CALIFORNIA COASTAL COMMISSION

ADOPTED COMMISSION FINDINGS AND CONDITIONS
COASTAL DEVELOPMENT PERMIT

Application No: 6-04-88

Description: Application from Southern California Edison and San Dieguito River Park Joint Powers Authority for implementation of the San Dieguito Wetland Restoration Plan and construction of a portion of the Coast to Crest Trail. The overall project includes creation/substantial restoration of about 150 acres of tidal wetland and about 15 acres of additional wetland habitat, initial inlet dredging and periodic dredging to permanently maintain an open inlet, construction of three berms, including permanent access roads, adjacent to the San Dieguito River to confine existing flows and maintain sediment transport to the ocean, bank protection for portions of the berms and river channel, culverts in the berms to help balance water levels and a weir to eliminate any backwater effect on the upstream river channel, creation of four new nesting sites and rehabilitation of an existing site for the California Least Tern and Western Snowy Plover, creation of treatment ponds to filter freshwater runoff and reduce freshwater flows into the restored tidal wetlands, cons

Figure 4.19. Engineering Plan for Treatment Ponds

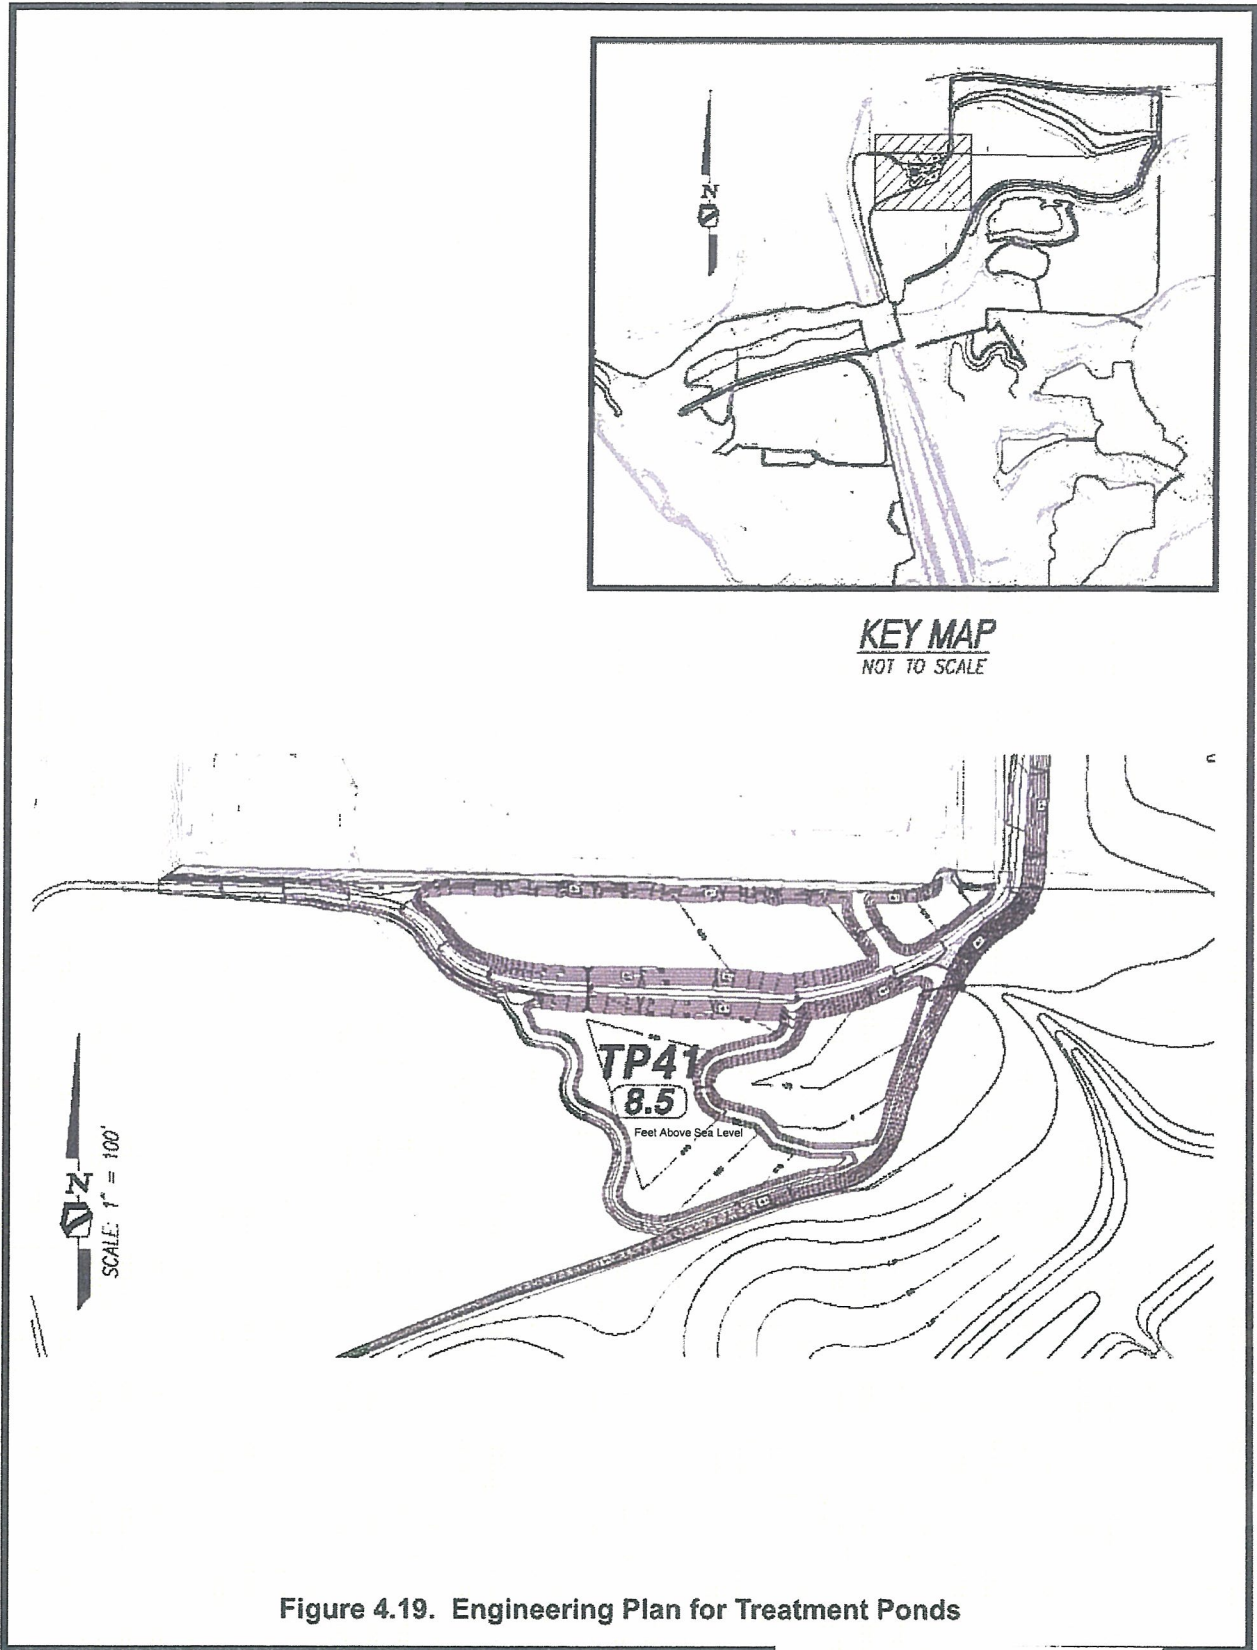
7. Freshwater Runoff Treatment Ponds. PRIOR TO THE COMMENCEMENT OF CONSTRUCTION OF THE FRESHWATER RUNOFF TREATMENT PONDS AND WITHIN 12 MONTHS OF THE COMMISSION'S APPROVAL OF THE FRP, the applicants shall submit final plans for the treatment ponds shown in TP41 to intercept and treat nuisance flows of polluted freshwater that originate in upstream areas of commercial and residential development and that currently flow untreated into the existing wetlands. Said plans shall be in substantial conformance with the document titled *M41 Parcel – Treatment Marsh Descriptions* submitted 2/11/04 and shall incorporate the following:

- b. Identification of all impacts from construction of the approved treatment ponds to existing wetlands as delineated in the *Wetland Delineation for the Proposed San Dieguito River Park Coast to Crest Trail, San Diego, California* prepared by Tierra Environmental Services, Inc. and revised July 14, 2005. Disturbance to no more than approximately 4.4 acres of existing delineated wetlands shall be permitted for construction of the treatment ponds and pond berms as shown on Exhibit 13, Tierra Matrix.

EXHIBIT NO. 16

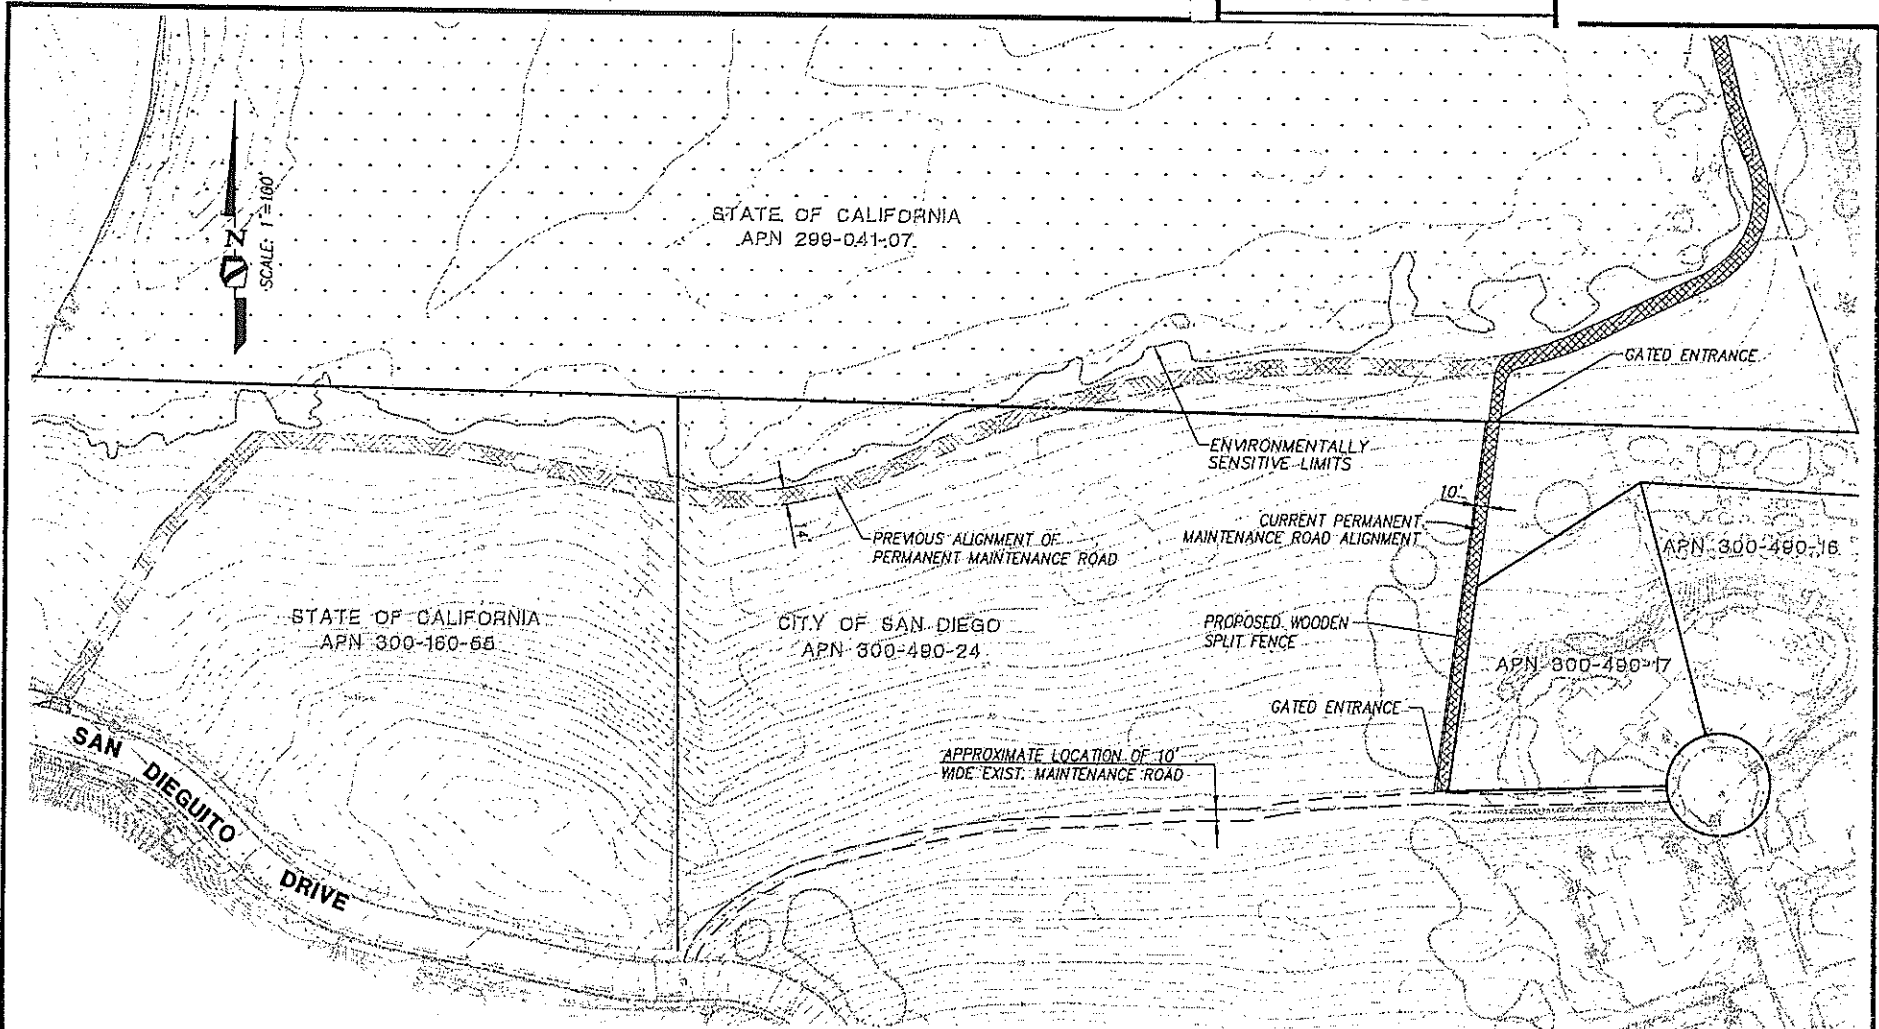
View Drive east toward I-5 shown on City of San Diego Sheets 7, 15 and 16 dated 5/26/05. The plans shall be in substantial conformance with the revised alignment shown on the plan dated 6/30/05 utilizing the existing road extending from Racetrack View Drive to the western property line of APN 300-490-17 in the Del Mar Estates subdivision. The revised plans shall incorporate the following:

- a. Year round public pedestrian use of the proposed maintenance road extending from Racetrack View Drive to the existing cul-de-sac as shown on the 6/30/05 plan. (Exhibit 16) A gate shall be installed at the DFG property boundary and access restricted north of the gate to authorized personnel only. The existing City of San Diego easement from the road to the cul-de-sac shall be open year around to public pedestrian use, except during rainy periods. Equestrian use and dog access shall be prohibited at all times.
